Technical Memorandum

- RE: Highway 286/Dave Ward Dr. Roundabout Review
- DT: February 11, 2015

As requested by the City of Conway, MTJ Engineering, LLC has completed an initial review of the three proposed roundabouts located along Dave Ward Drive.

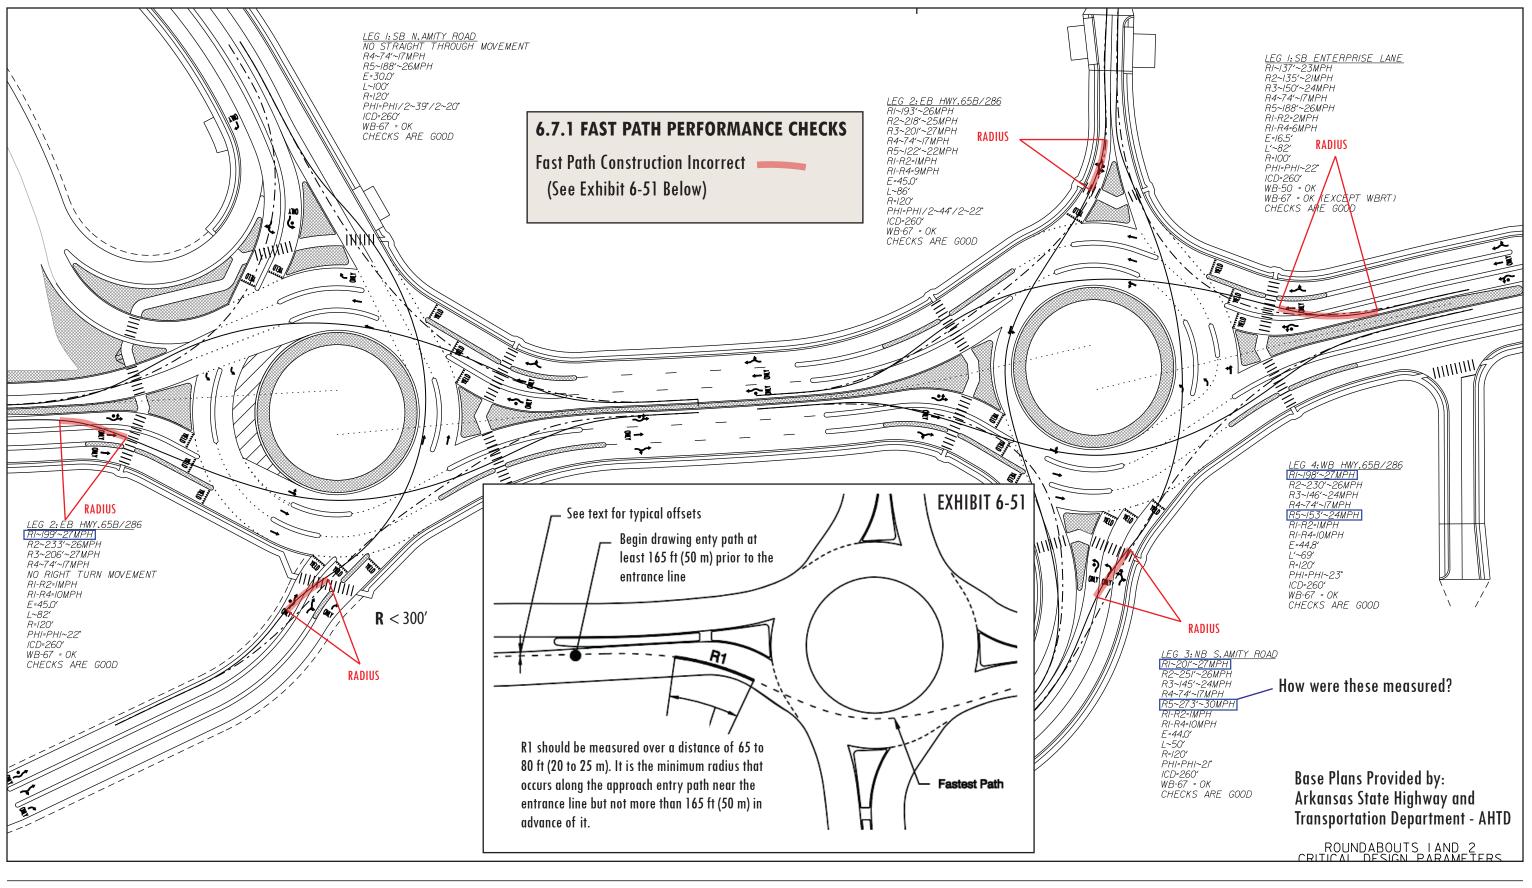
- The proposed horizontal geometrics and pavement markings are anticipated to create chronic crash problems to include:
 - Side swipes and failure-to-yield crashes due to driver confusion and lack of lane discipline at both entry and exit. This is based on recent case studies with similar design issues and outcomes within the U.S.
- Reduced pedestrian safety is expected due to:
 - Exit conflicts associated with the geometrics
 - Higher speeds at entry and exit pedestrian crossing locations.
- As currently proposed (with large ICDs and Fast Path Deficiencies) the design does not adhere to Pedestrian Facilitation goals and objectives as discussed and outlined in NCHRP 674 – Speeds, Refuge area deficiencies, Pedestrian Beacons (e.g., RRFB, Hawk, for multi-lane entry/exits designs).

Based on this geometric and pavement markings review, this project requires modifications to adhere to proven and established design principles and criteria as outlined in NCHRP 672 *(FHWA Roundabout Guide 2010).* The sketch level optimized design concept presented earlier in the Tech Memo (Figure #1) provides a concept sketch level design reflecting the laneage and geometric foundation from which to develop a revised preliminary design.

MTJ REVIEW - GEOMETRIC DESIGN PRINCIPLES - FAST PATHS CHECKS 2.3.2015

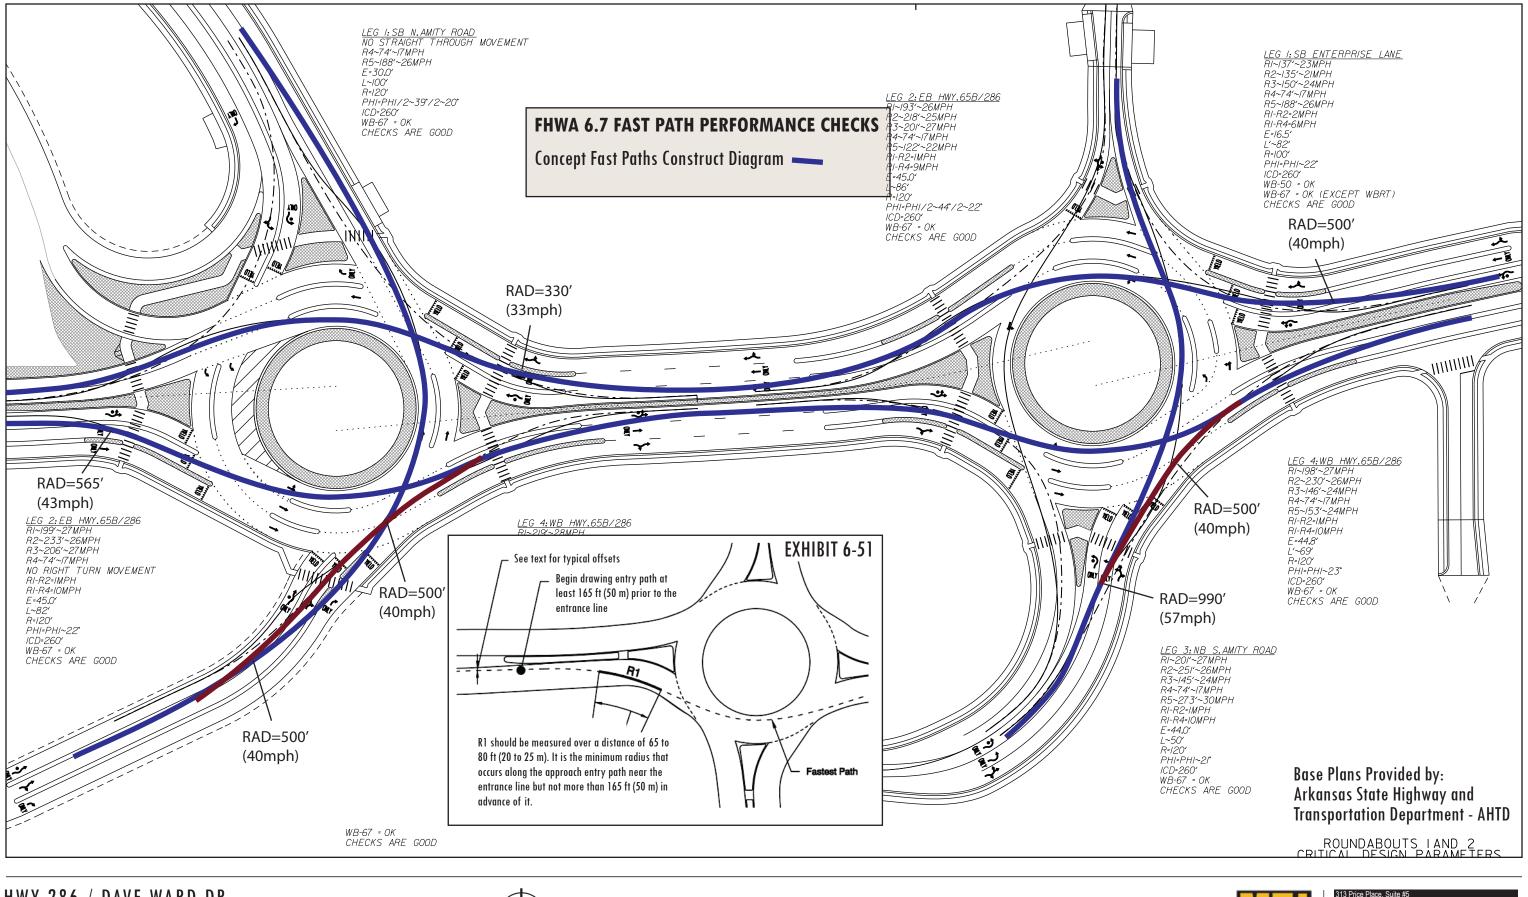
Our review found that the fast path analysis conducted on the currently proposed geometrics do not follow the correct method for the fast path constructs. Therefore, the measurements made from these erroneous fast path constructs are not accurate and are substantially non-compliant with FHWA fast path safety criteria. This is illustrated in the attached graphics, Exhibits 1 and 2.

MTJ REVIEW - GEOMETRIC DESIGN PRINCIPLES 2.3.2015

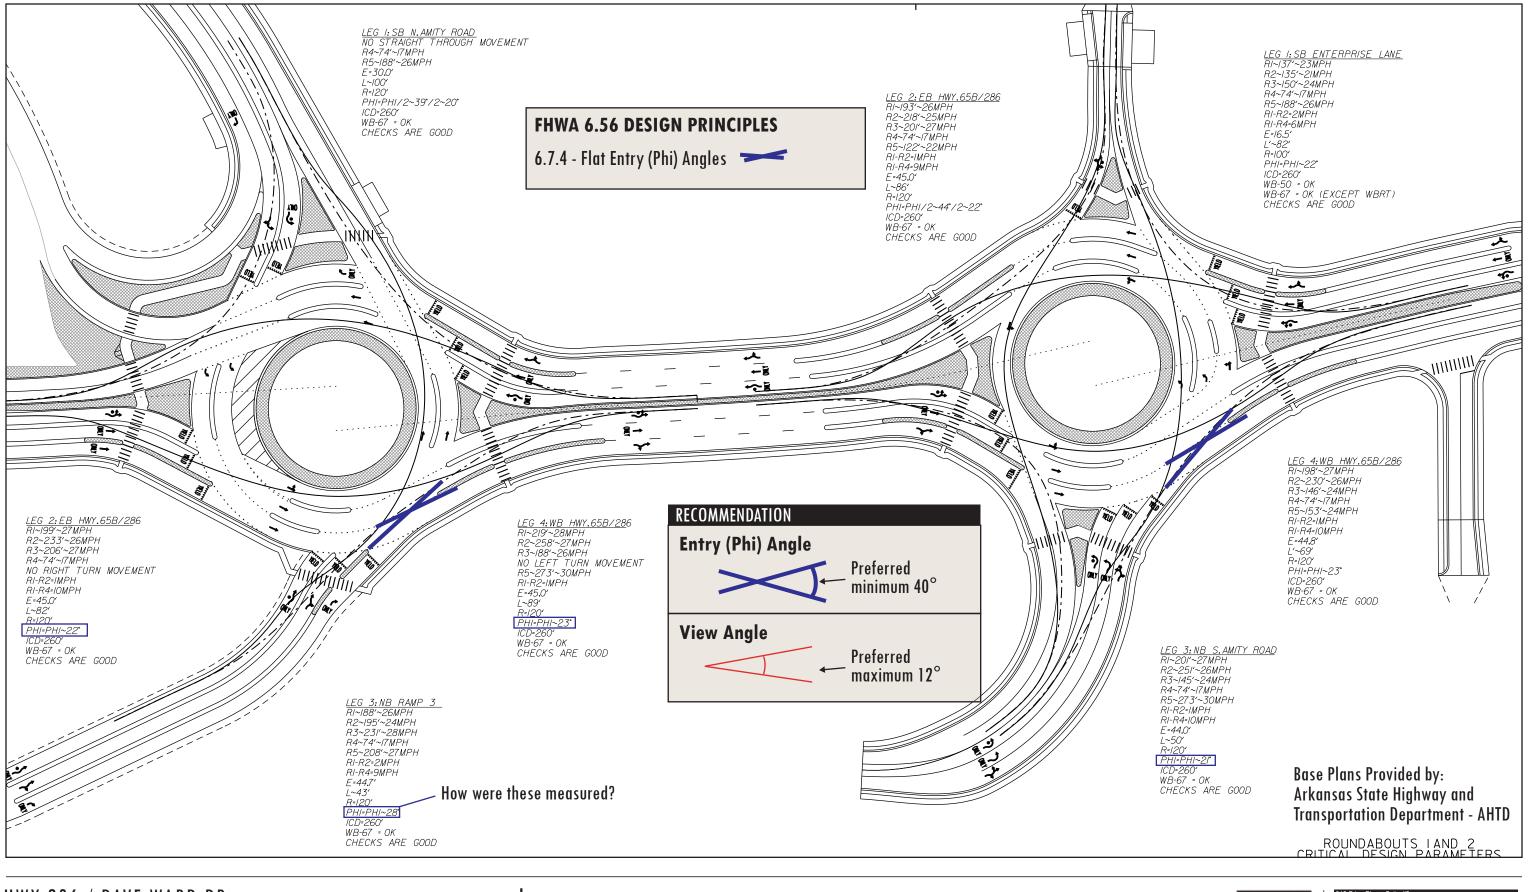
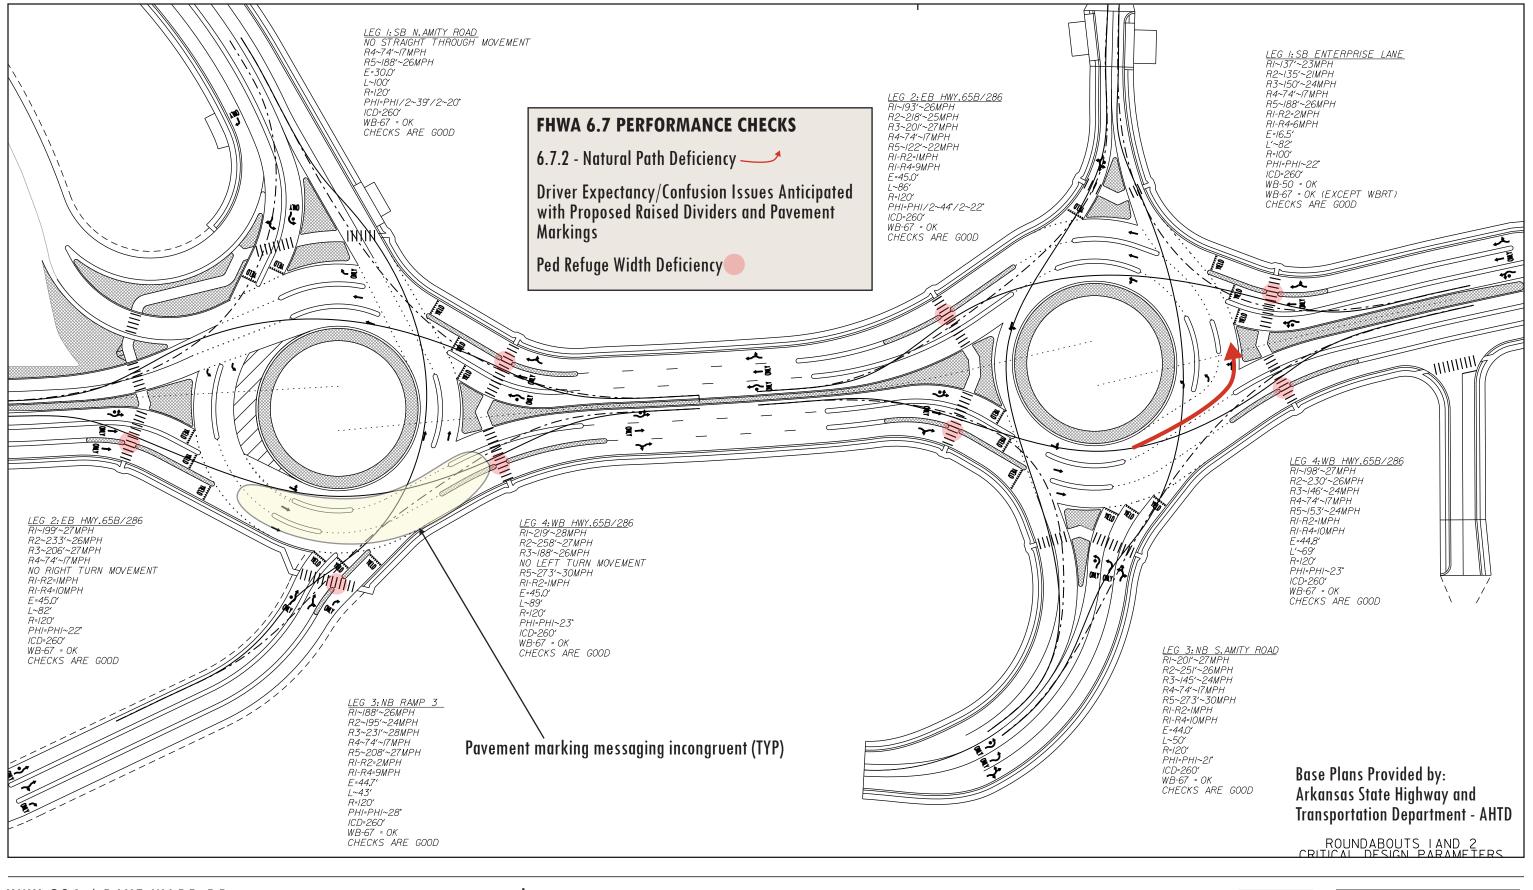
The currently proposed design does not meet minimum design standards for entry angles and angles of visibility. This issue is illustrated in the attached graphics, Exhibits 3 and 4.

MTJ REVIEW - GEOMETRIC DESIGN PRINCIPLES 2.3.2015

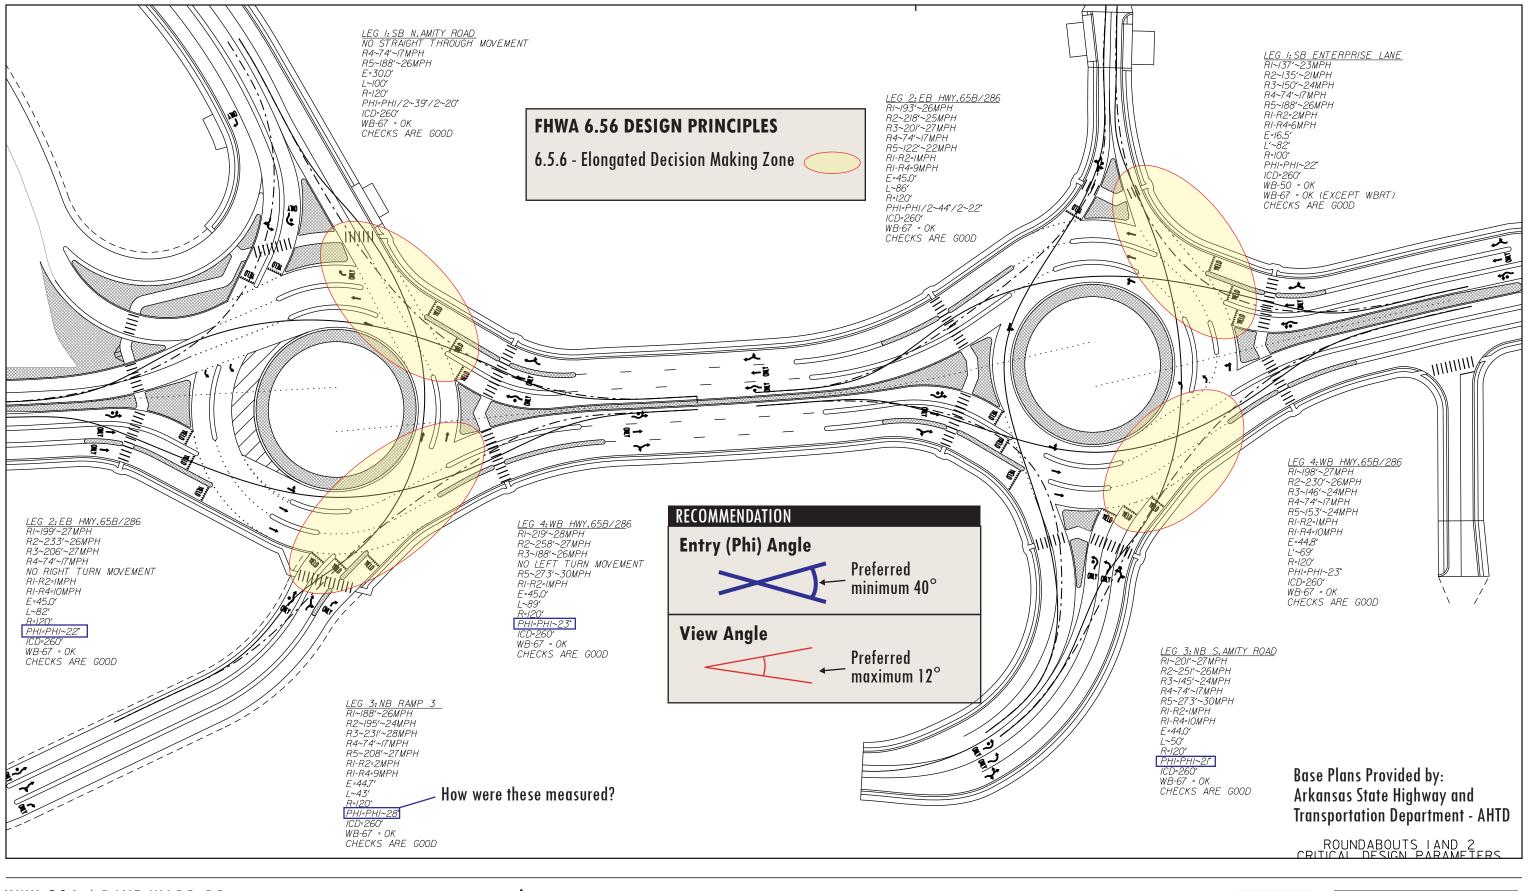
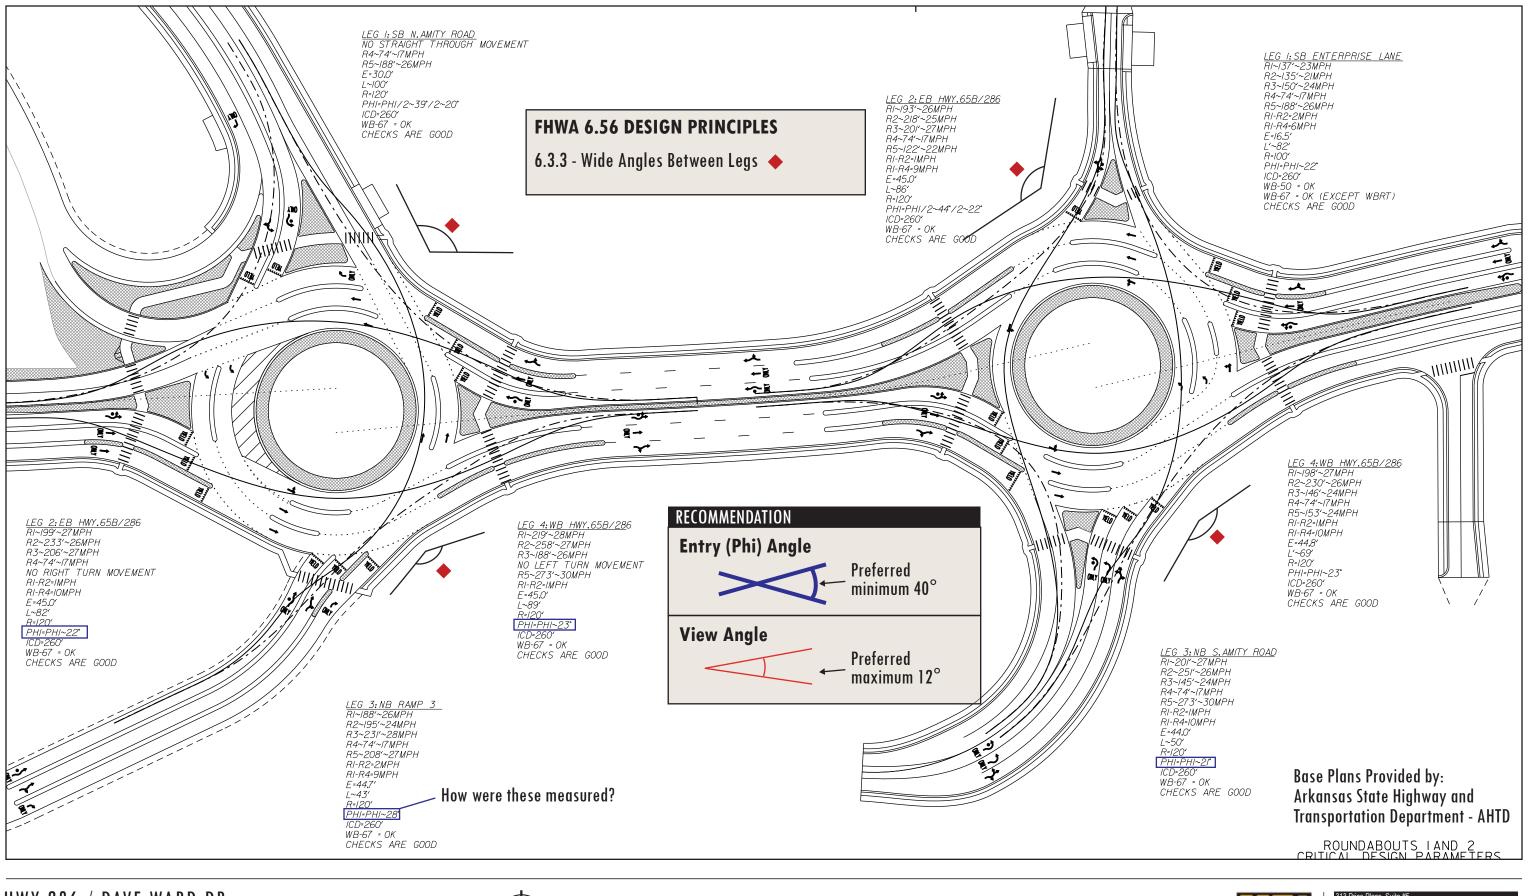
Line types, weight, and arrangement of pavement marking information are very important. The proposed design and pavement markings apply a blend of "Turbo" style raised dividers, with widened lane markings and skips. This arrangement of line types and raised dividers creates substantial concerns with respect to driver comprehension and safety for vehicular, motorcycle, and non-motorized traffic (pedestrian safety). Therefore, modifications are necessary to achieve more consistency with currently recognized pavement marking design principles in order to optimize driver comprehension. Please see attached graphics, Exhibit 5. After the Stage I Review is completed, pavement marking recommendations will be finalized.
